NAVIGATION - STALL WARNING HORN REPLACEMENT

The original stall warning horn is no longer available. If the stall warning horn needs to be replaced, a new stall warning horn is available and will require an additional bracket for installation.

CQB-34-01
Page 1 of 18

Figure 1. Before Modification (Sheet 1)

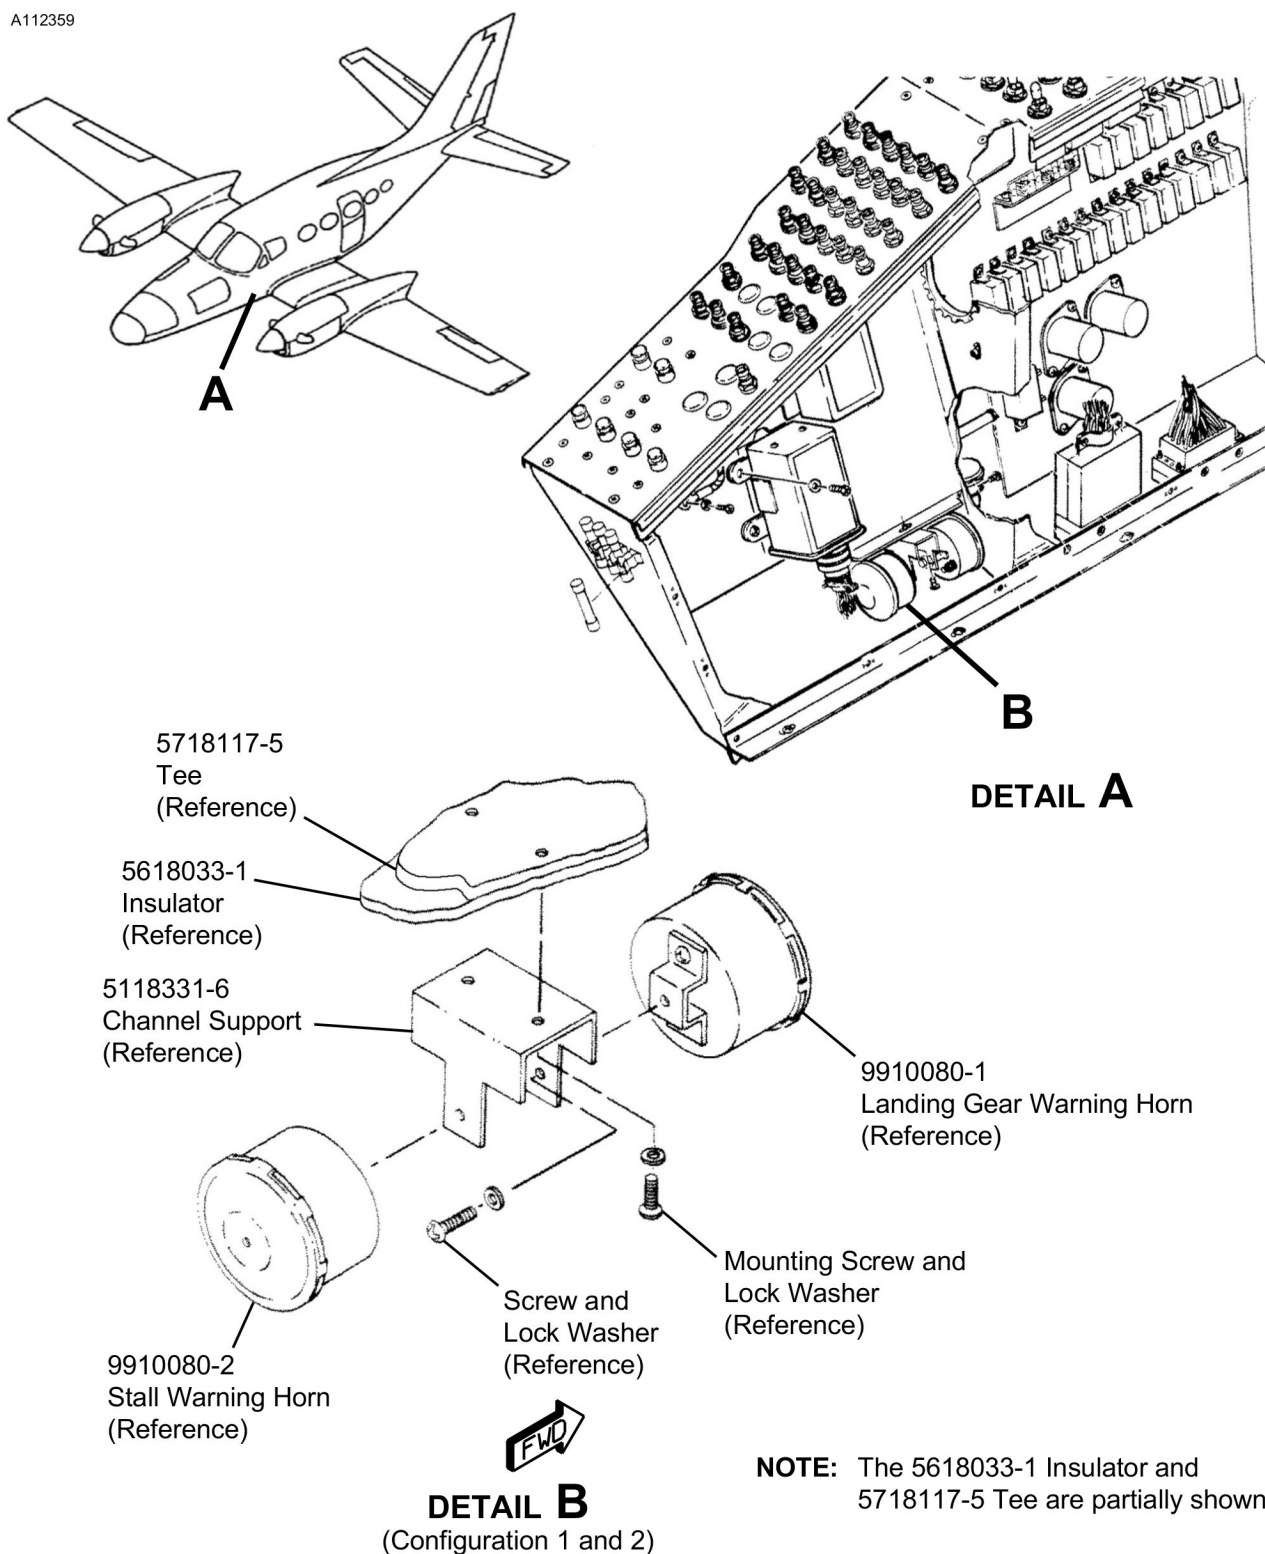
2. (Refer to Figure 1, Sheet 1.) Remove the 9910080-2 Stall Warning Horn as follows:
 - A. Disconnect and label the electrical wiring from the 9910080-1 Landing Gear Warning Horn and the 9910080-2 Stall Warning Horn.
 - B. Remove the four rivets from the 5718117-5 Tee. (Refer to the applicable Maintenance Manual, Chapter 51, Fastener Installation and Removal.)
 - C. Remove and discard the screw, nut, and lock washer from the 9910080-1 Landing Gear Warning Horn.
 - D. Remove and discard the screw, nut, and lock washer from the 9910080-2 Stall Warning Horn.
 - E. Remove and keep the two mounting screws from the 5118331-6 Channel Support.

8. (Refer to Figure 1, Sheet 1.) Remove the 9910080-2 Stall Warning Horn as follows:
 - A. Disconnect and label the electrical wiring from the 9910080-1 Landing Gear Warning Horn and the 9910080-2 Stall Warning Horn.

Figure 2. After Modification (Sheet 1)

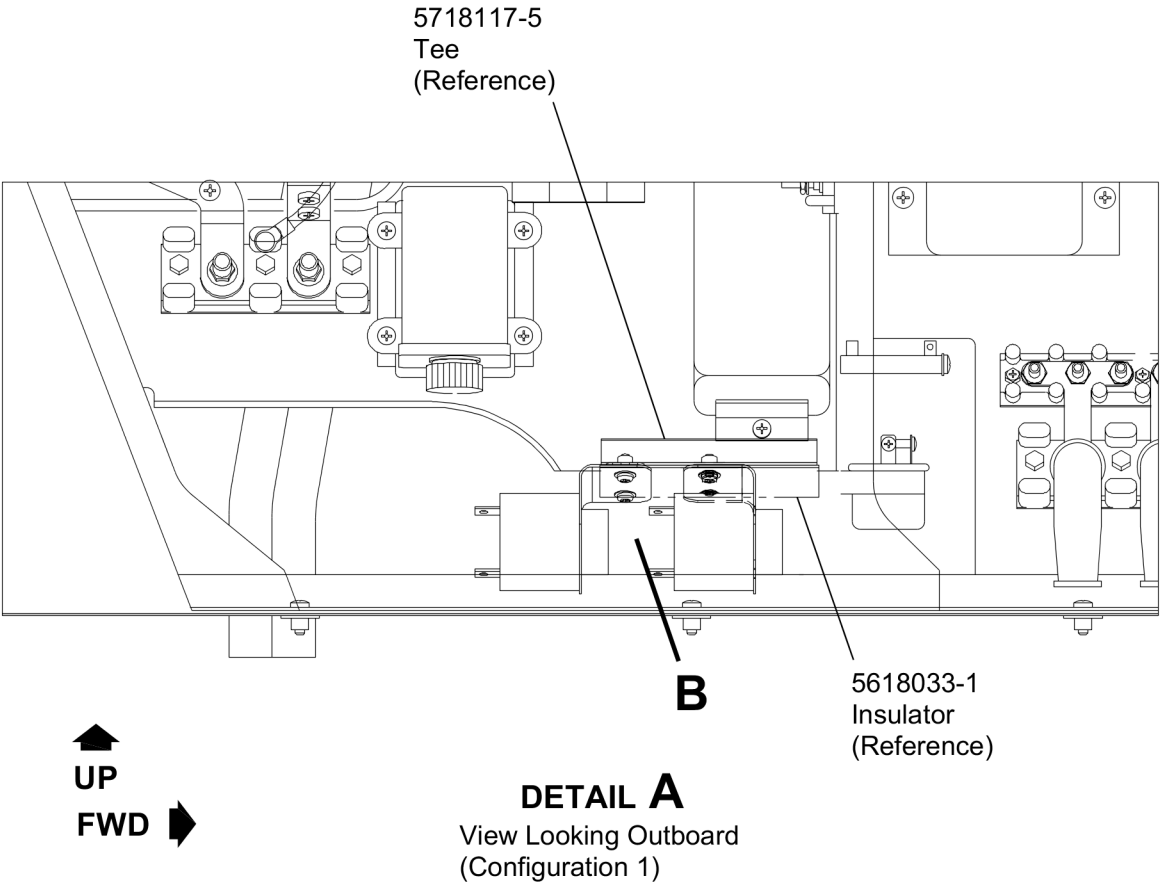
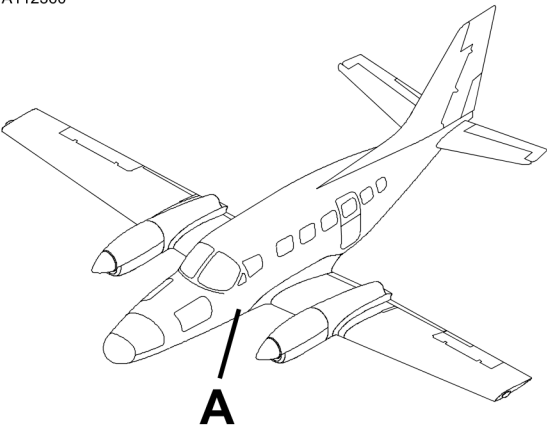
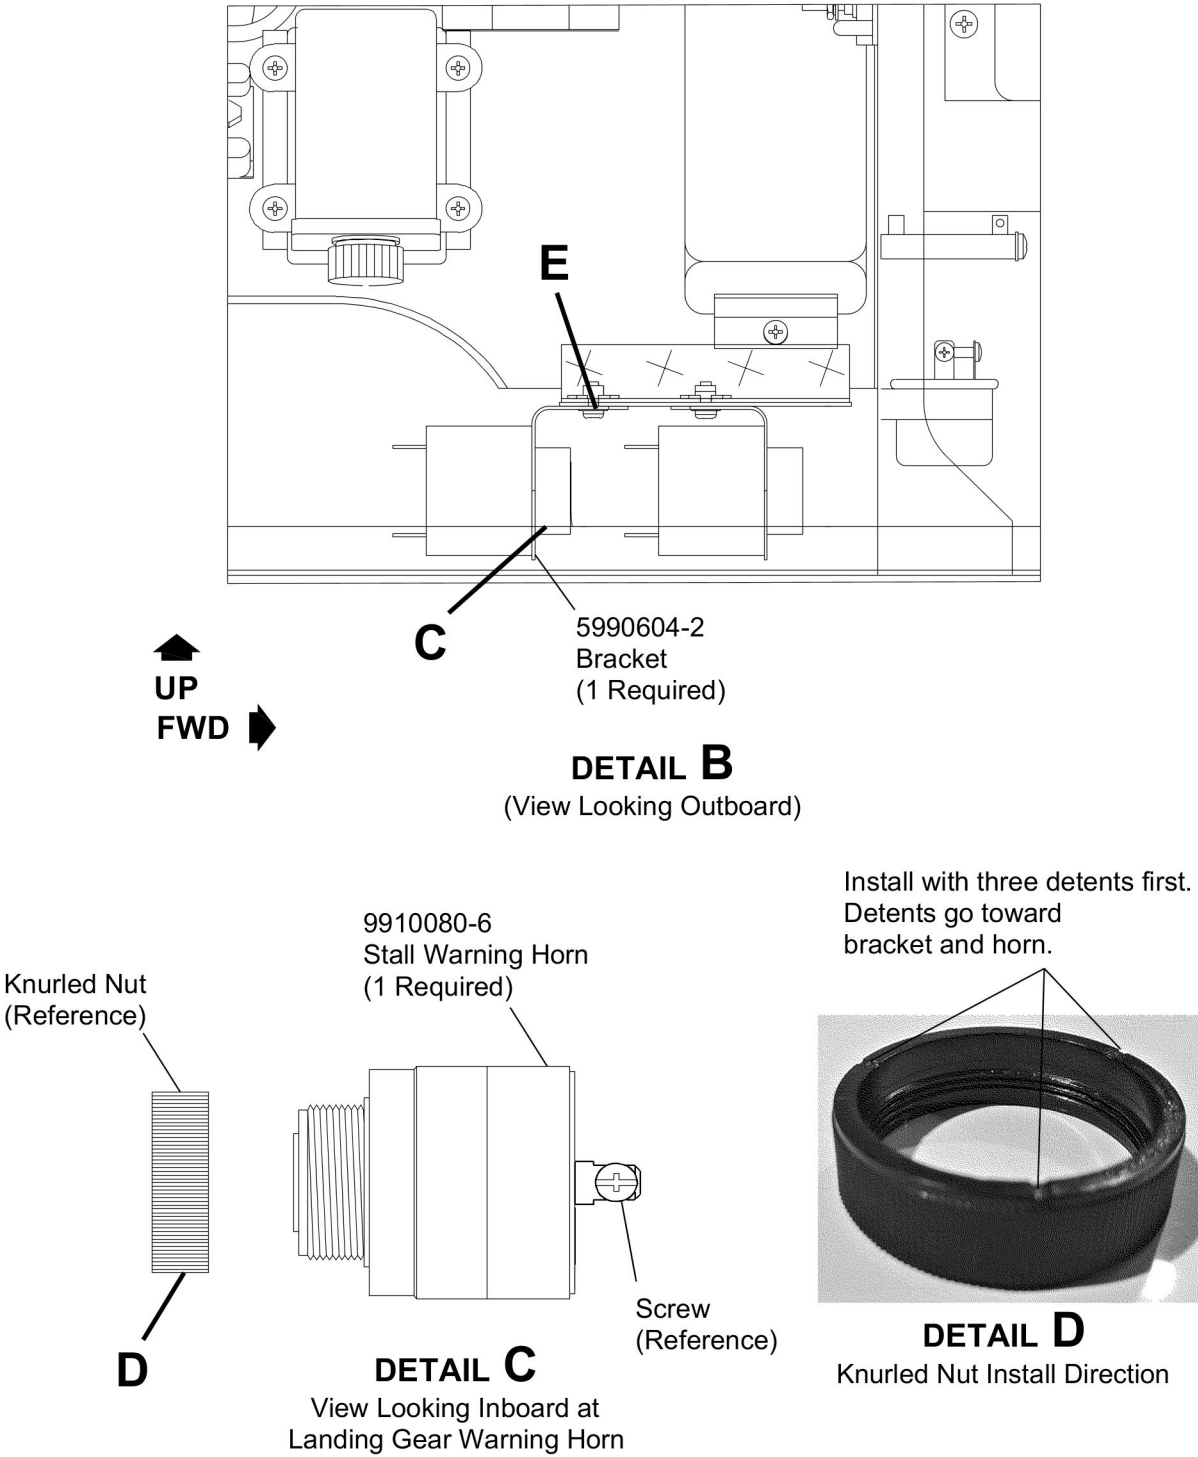
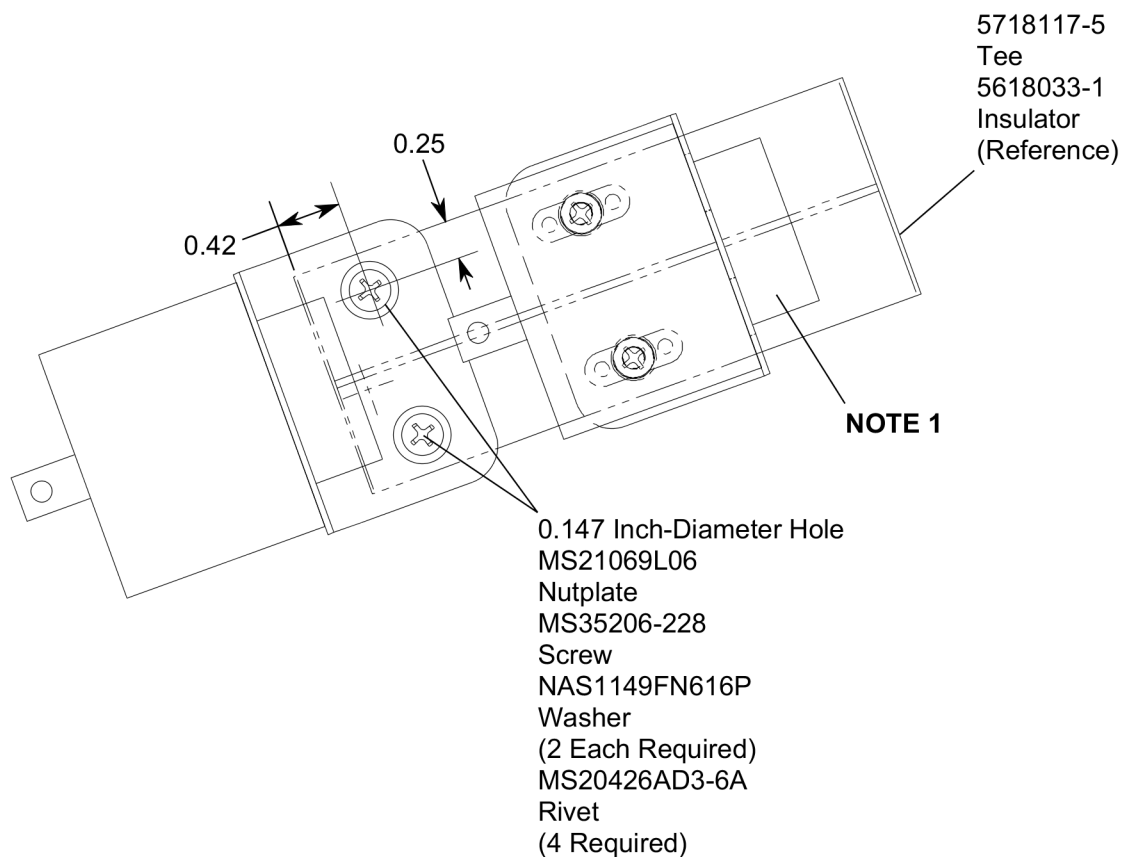
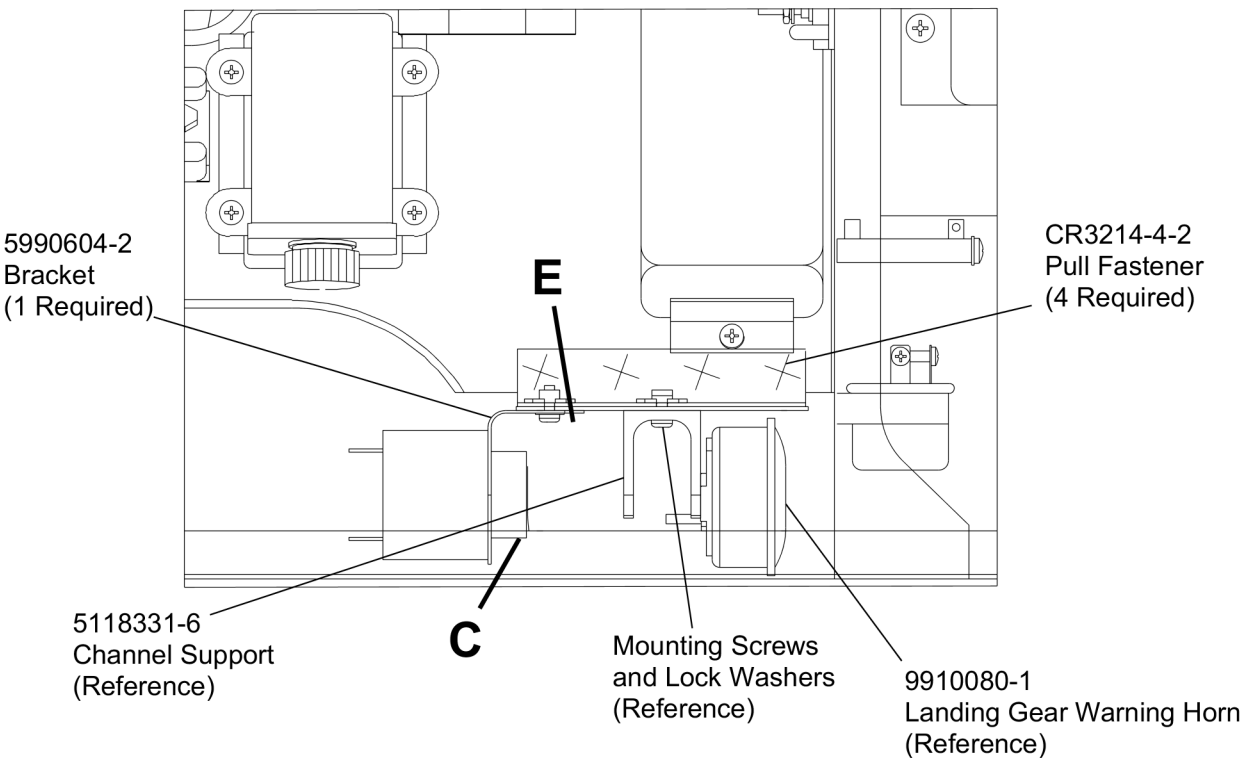
NOTE: The kept 5618033-1 Insulator will be used for installation.
3. (Refer to Figure 2, Sheet 1, 2, and 3.) Install the 9910080-6 Stall Warning Horn as follows:

- A. Align the existing holes of the 5618033-1 Insulator onto the 5718117-5 Tee.
 - B. Put the 5990604-2 Bracket onto the 5618033-1 Insulator.
 - C. Match drill the two 0.147 inch diameter holes of the 5990604-2 Bracket into the 5618033-1 Insulator and the 5718117-5 Tee.

- (1) Deburr the drilled holes from the 5618033-1 Insulator and the 5718117-5 Tee.
 - (2) Apply Color Chemical Film Treatment to all bare metal.
 - D. Install two MS21069L06 Nutplates with four MS20426AD3-6A Rivets onto the 5718117-5 Tee. (Refer to the applicable Maintenance Manual, Chapter 51, Fastener Installation and Removal.)

- E. Put the drilled holes of the 5618033-1 Insulator onto the drilled holes of the 5718117-5 Tee.
 - F. Install the 5990604-2 Bracket with two MS35206-228 Screws and two NAS1149FN616P Washers.

- G. Install the 9910080-6 Stall Warning Horn into the 5990604-2 Bracket.
 - H. Install the knurled nut onto the 9910080-6 Stall Warning Horn.

NOTE: The plastic knurled nut must be installed with the three indents toward the bracket and horn assembly. On the internal circumference, the smooth side without threads is installed first, towards the bracket and horn. This technique of installation will make sure the nut fully seats against the bracket and not bottom-out on the threads. If not installed correctly the knurled nut will bottom-out on the threads and the horn assembly will not be fully tightened to the bracket.
 - I. Install the 9910080-5 Landing Gear Warning Horn. (Refer to CQB-32-01: Landing Gear Warning Horn Replacement, **CONFIGURATION 1**.)
 - J. Install the 5718117-5 Tee. (Refer to CQB-32-01: Landing Gear Warning Horn Replacement, **CONFIGURATION 1**.)
 - K. Install the labeled electrical wiring and screws into the 9910080-6 Stall Warning Horn.

Figure 3. After Modification (Sheet 2)

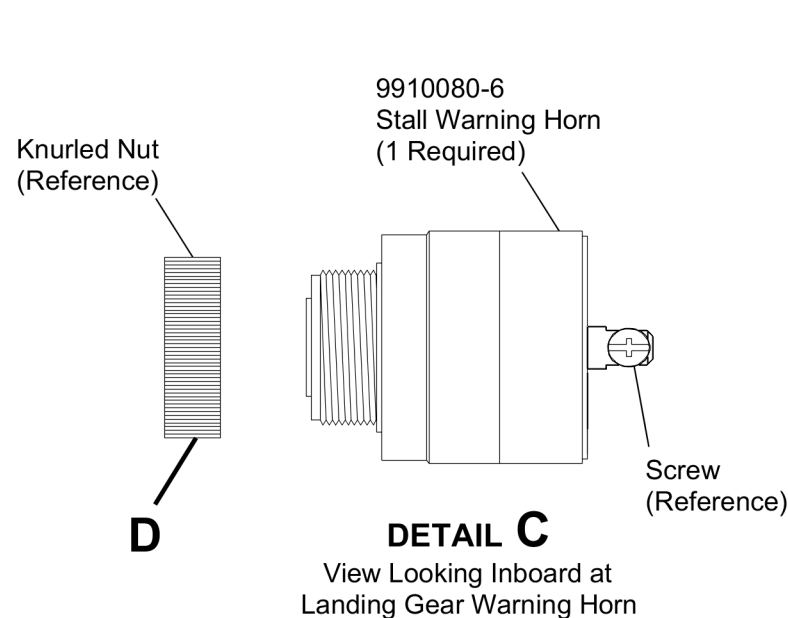
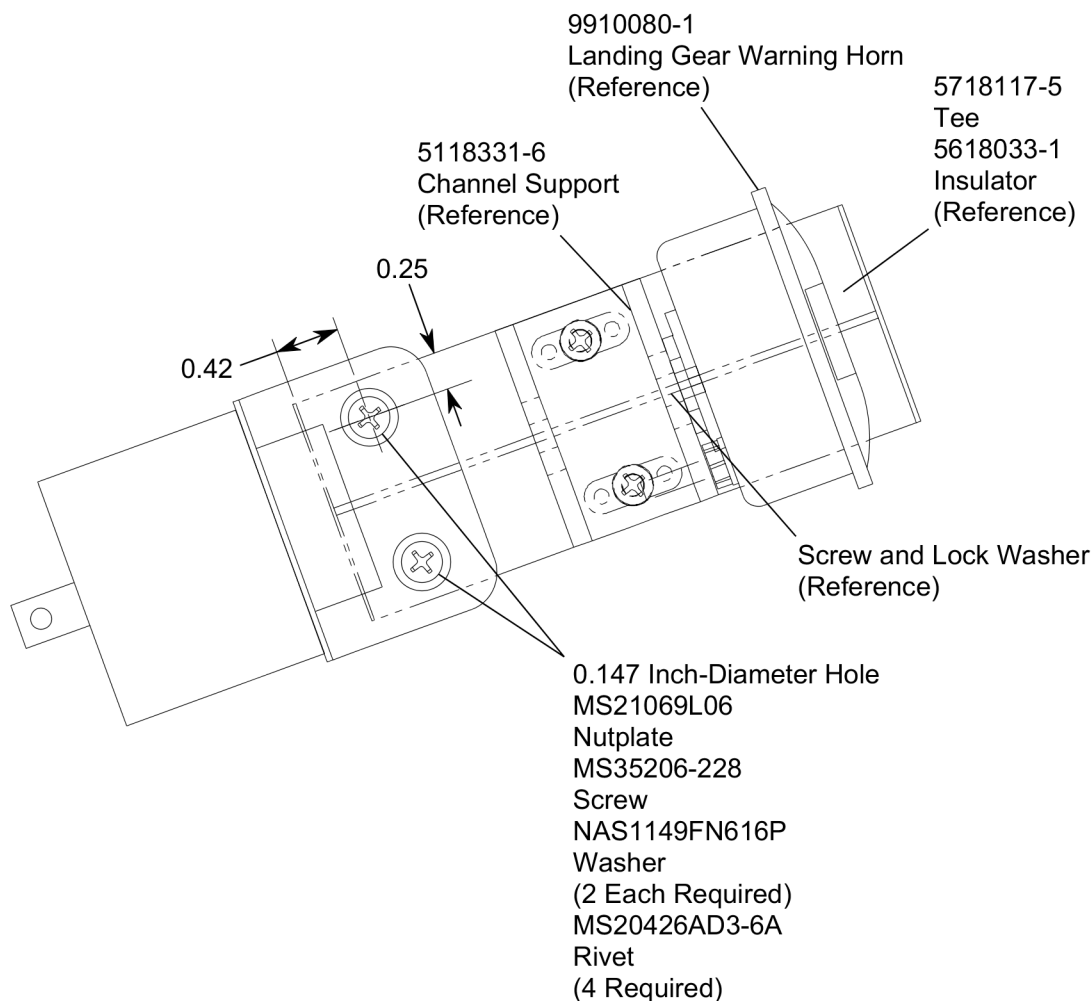
9. (Refer to Figure 3, Sheet 1, 2, and 3.) Install the 9910080-6 Stall Warning Horn as follows:
 - A. Align the existing holes of the 5618033-1 Insulator onto the 5718117-5 Tee.

- B. Put the 5990604-2 Bracket onto the 5618033-1 Insulator.
 - C. Match drill the two 0.147 inch diameter holes of the 5990604-2 Bracket into the 5618033-1 Insulator and the 5718117-5 Tee.

- (1) Debur the drilled holes from the 5618033-1 Insulator and the 5718117-5 Tee.
 - (2) Apply Color Chemical Film Treatment to all bare metal.
 - D. Install two MS21069L06 Nutplates with four MS20426AD3-6A Rivets onto the 5718117-5 Tee. (Refer to the applicable Maintenance Manual, Chapter 51, Fastener Installation and Removal.)

- E. Put the drilled holes of the 5618033-1 Insulator onto the drilled holes of the 5718117-5 Tee.
 - F. Install the 5990604-2 Bracket with two MS35206-228 Screws and two NAS1149FN616P Washers.

- G. Install the 9910080-6 Stall Warning Horn into the 5990604-2 Bracket.
 - H. Install the knurled nut onto the 9910080-6 Stall Warning Horn.
NOTE: The plastic knurled nut must be installed with the three indents toward the bracket and horn assembly. On the internal circumference, the smooth side without threads is installed first, towards the bracket and horn. This technique of installation will make sure the nut fully seats against the bracket and not bottom-out on the threads. If not installed correctly the knurled nut will bottom-out on the threads and the horn assembly will not be fully tightened to the bracket.

- I. Install the 5118331-6 Channel Support with the mounting screws and lock washers into the existing holes of the 5618033-1 Insulator.

- J. Install the 9910080-1 Landing Gear Warning Horn onto the forward side of the 5118331-6 Channel Support with the screw and lock washer.
- K. Install the 5718117-5 Tee with four CR3214-4-2 Pull Fasteners onto the frame.
- L. Install the labeled electrical wiring into the 9910080-1 Landing Gear Warning Horn.
- M. Install the labeled electrical wiring and screws into the 9910080-6 Stall Warning Horn.

Figure 4. Before Modification (Sheet 1)

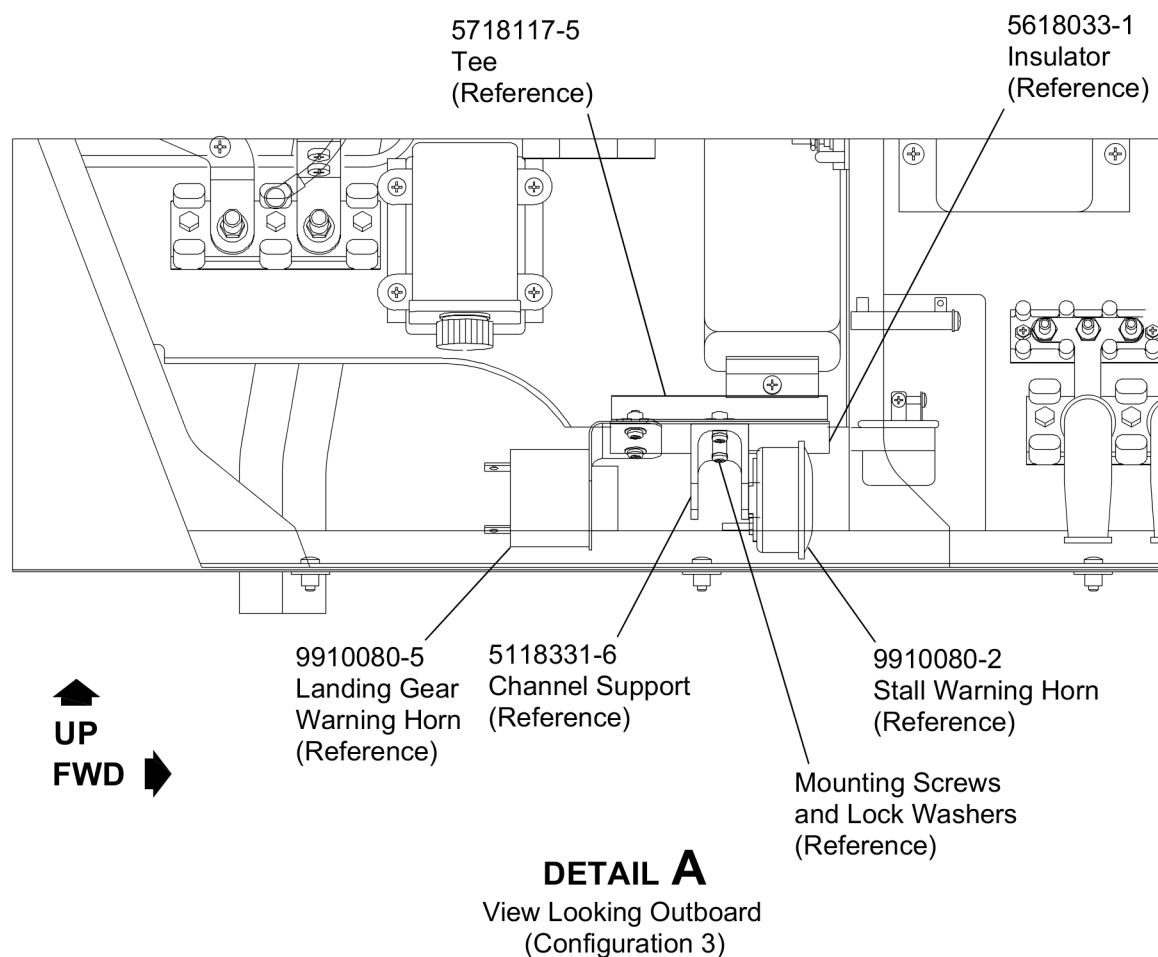
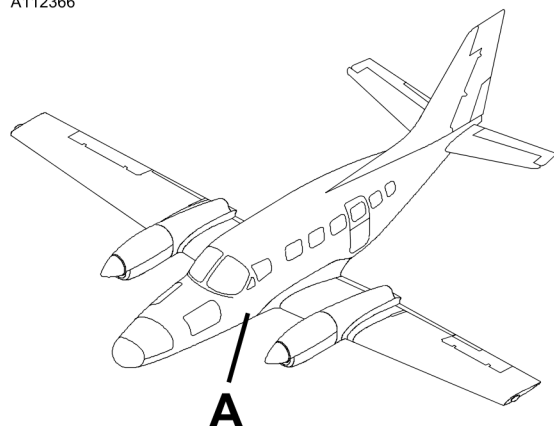
- 15. (Refer to Figure 4, Sheet 1.) Remove the 9910080-2 Stall Warning Horn as follows:
 - A. Disconnect the electrical wiring from the 9910080-2 Stall Warning Horn.
 - B. Remove and discard the screw and lock washer from the 9910080-2 Stall Warning Horn.
 - C. Discard the 9910080-2 Stall Warning Horn.

- D. Remove and keep the mounting screws from the 5118331-6 Channel Support.

- E. Discard the lock washers and the 5118331-6 Channel Support.
